PCN# : P634AAB  
Issue Date : Mar. 10, 2016

### Information Only Notification

Figure 1. Typical Application

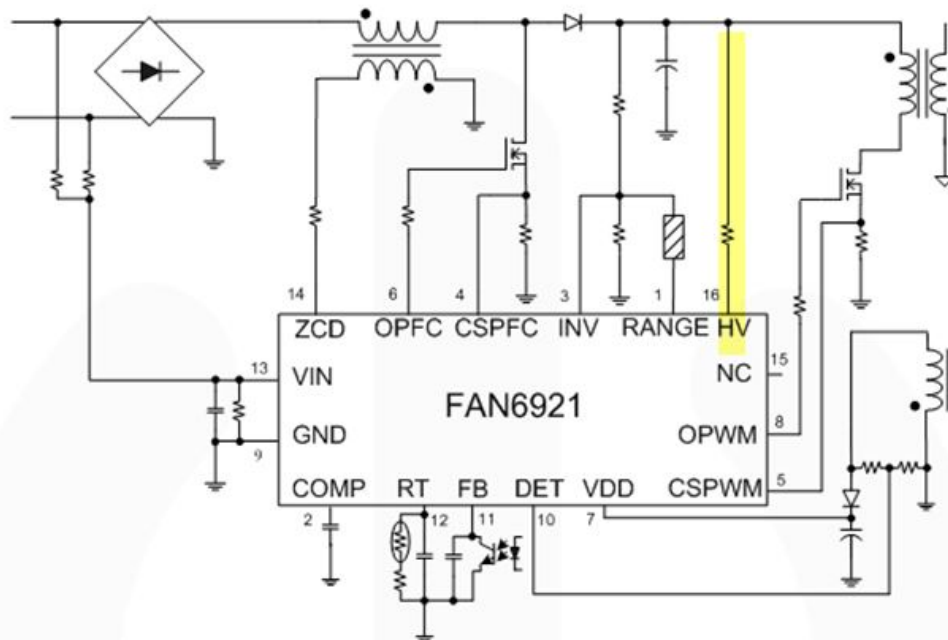
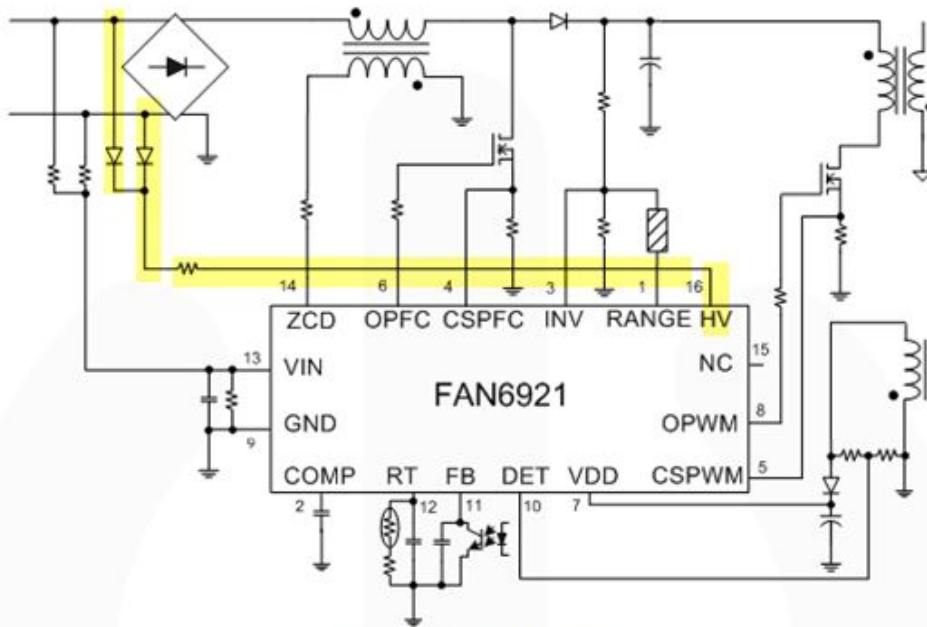
Figure 1, Typical Application Drawing (Page 2), HV Pin is connected to bulk:

Figure 1, Typical Application Drawing (Page 2), HV Pin is connected to AC Line:

Reason for Change:  
Datasheet change only.

Fairchild is correcting the error found with application drawing on HV pin to correct to proper level and is changing to suitable application drawing. This new configuration will avoid entering latch-off protection when on/off testing is performed.
